ADDENDUM NO. 2

GAGE DRAIN PUMP STATION AND OPEN CHANNEL SAGINAW COUNTY, MICHIGAN

RE: CHANGES TO BIDDING DOCUMENTS

ACCEPTABLE MANUFACTURERS:
 - SEVES GLASS BLOCK INC. (877) 738-3711
 - ARCHITECT APPROVED EQUAL

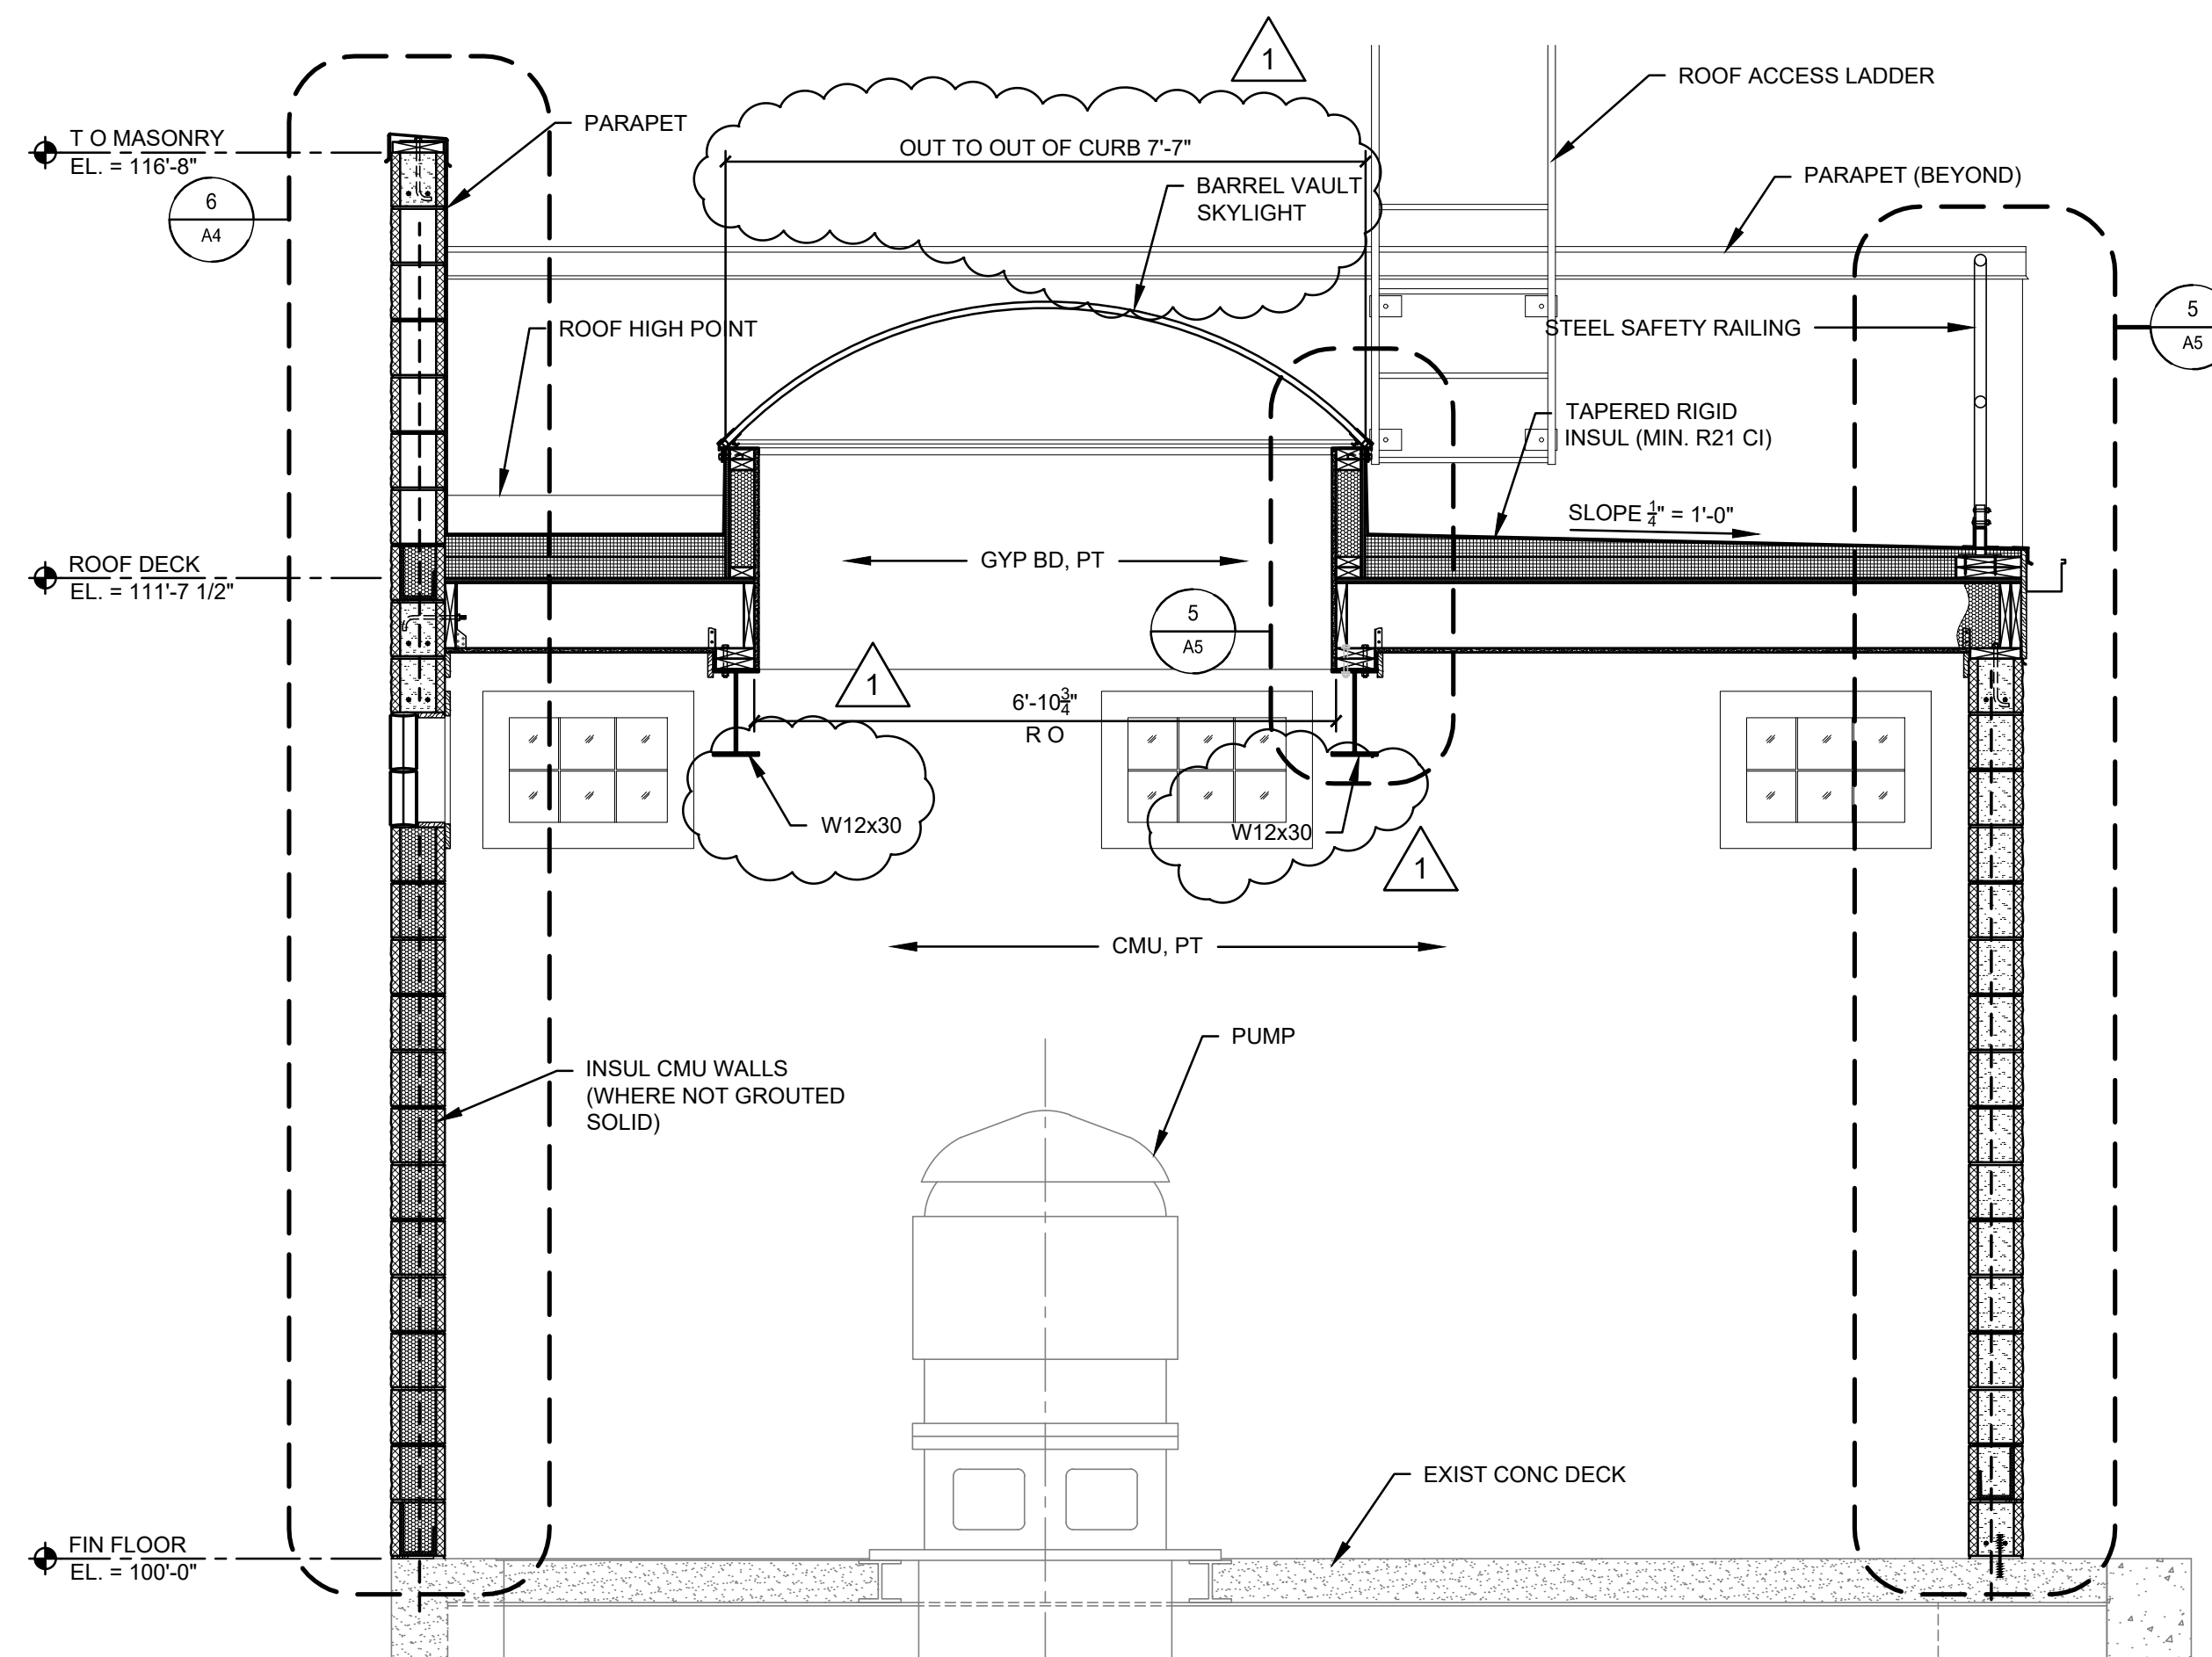
1. Addendum No. 2 has been posted to the Saginaw County Public Works Commissioner's website on Wednesday, February 17th, 2021.
2. Division I - Sheet A3 (Sheet 33 of 41 in the plan set) has been revised and reissued as part of this addendum to add a support beam for the roof in the electrical/control room. The revised Sheet A3 also has added notes and details in response to bidder questions regarding the glass block windows and the barrel vault skylight.

- The contractor will be responsible for providing the warning light and audio alarm for the trash rack.
 - Additional information for the glass block windows is included in the revised A3 sheet included with this addendum.

- Additional information for the barrel vault skylight is included in the revised A3 sheet included with this addendum.
4. Division II Clarifications in response to bidder questions:

NOTE:
 W8x24 BEAM IN ELECTRICAL ROOM SHALL BE IN-LINE WITH EASTERN MOST BEAM IN PUMP ROOM

BARREL VAULT SKYLIGHT SYSTEM NOTES:

SUPPLY AND INSTALL COMPLETE AN ACRYLIC DOMED SKYLIGHT SYSTEM AS SHOWN ON THE DRAWINGS.

- SKYLIGHT SHALL BE CONSTRUCTED AND INSTALLED TO ENSURE A WEATHER TIGHT INSTALLATION. SKYLIGHT SHALL HAVE SPECIAL LIFTING LUGS FOR RIGGING AND REMOVAL BY CRANE STRAPS.

- SKYLIGHT FRAME, GLAZING TRACK, MULLIONS AND RAFTERS SHALL BE CONSTRUCTED OF ALUMINUM. FRAME SHALL BE CURB MOUNTED. FRAME SHALL HAVE A POLYURETHANE THERMAL BREAK AND AN INTEGRAL GUTTER AND WEEP SYSTEM FOR DRAINAGE TO THE EXTERIOR. FRAME CONSTRUCTION SHALL BE WELDED.

- ACRYLIC DOMES SHALL BE BRONZE OVER CLEAR. DOMES SHALL BE SECURED TO FRAME WITH A FULLY WELDED RETAINER CAP.
- ALL EXPOSED ALUMINUM SHALL BE MILL FINISH. ALL GLAZING SHALL BE SEPARATED FROM FRAME BY A CONTINUOUS EXTRUDED BLACK SANTOPRENE GASKET. ALL HARDWARE SHALL BE STAINLESS STEEL.

- SKYLIGHT SHALL BE FACTORY ASSEMBLED AND FACTORY GLAZED. SKYLIGHT SHALL BE INSTALLED IN STRICT ACCORDANCE WITH MANUFACTURERS INSTRUCTIONS.
- BARREL VAULT SKYLIGHT SHALL BE FASTENED TO CURB WITH BOLTS AND T-NUTS OR THREADED INSERTS EMBEDDED IN THE CONSTRUCTED CURB. FASTENERS SHALL MEET MANUFACTURERS RECOMMENDATIONS FOR SIZE AND SPACING WITH A MAXIMUM SPACING OF 12" O.C.

GLASS BLOCK NOTES:

SUPPLY AND INSTALL 8"x8"x4" GLASS BLOCKS IN INDIVIDUAL UNITS AS SHOWN ON THE DRAWINGS.

PRODUCT:
 1. THICK FACED GLASS BLOCK UNITS, NOMINALLY 8"x8"x4" THICK SHALL BE PARTIALLY EVACUATED HOLLOW UNITS MADE OF CLEAR, COLORLESS GLASS WITH A POLYVINYL BUTYRAL EDGE COATING.

- PATTERN TYPE: EQUAL TO SEVES WAVE
- MORTAR: LIMIT CEMENTITIOUS MATERIALS IN MORTAR TO PORTLAND CEMENT AND LIME. TYPE S IN ACCORDANCE WITH ASTM C270. MORTAR SHALL BE 1 PART PORTLAND CEMENT, 1/2 PART LIME, AND SAND EQUAL TO 2 1/2 TO 3 TIMES THE AMOUNT OF CEMENTITIOUS MATERIAL (CEMENT PLUS LIME), ALL MEASURED BY VOLUME. (FOR EXTERIOR GLASS BLOCK PANELS, AN INTEGRAL TYPE WATERPROOFER SHOULD BE ADDED TO THE MORTAR MIX.) NO ANTIFREEZE COMPOUNDS OR ACCELERATORS ALLOWED. TYPE N MORTAR IS ALSO ACCEPTABLE.

- GLASS BLOCK SHALL NOT BE DESIGNED TO SUPPORT STRUCTURAL LOADS.
- SILLS OF ALL PANELS MUST BE PAINTED WITH A HEAVY COAT OF ASPHALT EMULSION AND MUST CURE FOR TWO HOURS BEFORE FIRST MORTAR BED IS PLACED.
- MORTAR SHOULD BE MIXED AND APPLIED IN ACCORDANCE WITH THE RECOMMENDATIONS OF MANUFACTURER.
- BECAUSE GLASS BLOCK WILL NOT ABSORB WATER, MORTAR MUST BE CONSIDERABLY STIFFER THAN MORTAR FOR ORDINARY MASONRY. THE CONSISTENCY CAN BE DESCRIBED AS "MASHED POTATOES" OR "PEANUT BUTTER" AND BE CLAY-LIKE. THE JOINTS MUST BE FULL AND STRUCK SMOOTH, NOT SPONGED.
- INSTALLATION OF GLASS BLOCK SHALL BE DONE BY WHOLE UNITS. CUTTING OF GLASS BLOCK UNITS IS NOT PERMITTED.
- SUBMIT TWO (2) GLASS BLOCK UNITS OF EACH TYPE SPECIFIED, SHOWING SIZE, DESIGN AND PATTERN OF FACES.
- VERIFY ALL INSTALLATION INSTRUCTIONS WITH PRODUCT MANUFACTURERS INSTRUCTIONS.
